City of Mississauga  
**Corporate Report**

**Proposed Zoning By-law Amendments and Urban Design Guidelines for Back to Back and Stacked Townhouses**

**File: CD.06 HOR**

Figure 11: Permitted projections over below grade private outdoor patios

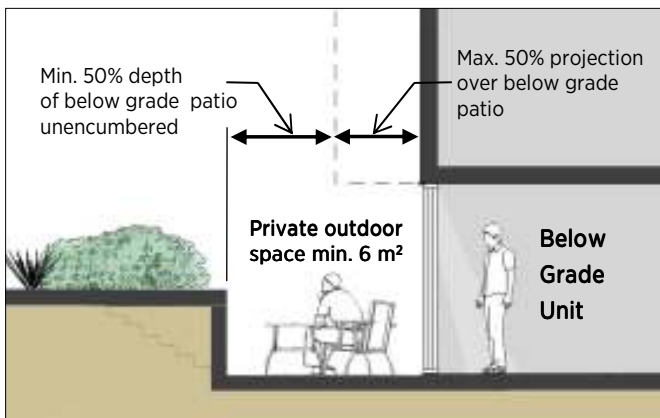
- Basement units are no longer prohibited. An additional regulation has been added to ensure the design of below grade amenity areas allows for increased light penetration into units. The newly proposed regulation prohibits any first storey projections from exceeding 50% of the depth of a below grade patio

Figure 12: Setbacks from the building's exterior edge

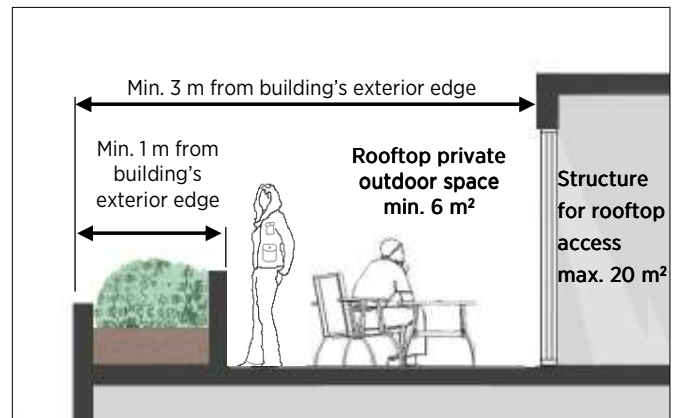
- The minimum setback of a rooftop amenity space from all exterior edges of a building has been reduced to 1.0 m (3.3 ft.) from the previously proposed 1.2 m (3.9 ft.). This change is to allow for an adequately sized rooftop amenity space balanced with the minimum setback requirements of structures for rooftop access. Additionally, greater clarity has been added to acknowledge that the 1.0 m (3.3 ft.) setback requirement only applies where the rooftop amenity space overlooks adjacent properties, not where it overlooks internal to the site

2	Mark Bozzo, Queenscorp Group	March 29, 2017	<p>The requirement for a 1.2 m (3.9 ft.) setback from a rooftop amenity space to all exterior edges of a building is concerning. The requirement should be reduced to 0.5 m (1.6 ft.).</p>	<p>Based on the requirement for a minimum of 6 m<sup>2</sup> (64.6 ft<sup>2</sup>) of private outdoor space per unit and the minimum 3 m (9.8 ft.) setback of rooftop mechanical rooms from the building edge, the City agrees that 1.2 m (3.9 ft.) may be excessive in some cases.</p> <p><b>ACTION:</b> The ZBL regulations and UDGs have been revised to reduce the requirement to 1.0 m (3.3 ft.) for rooftop amenity space to exterior edges. The UDGs also clarify that the requirement is only applicable where rooftop amenity spaces overlook abutting properties, not internal to the development.</p>
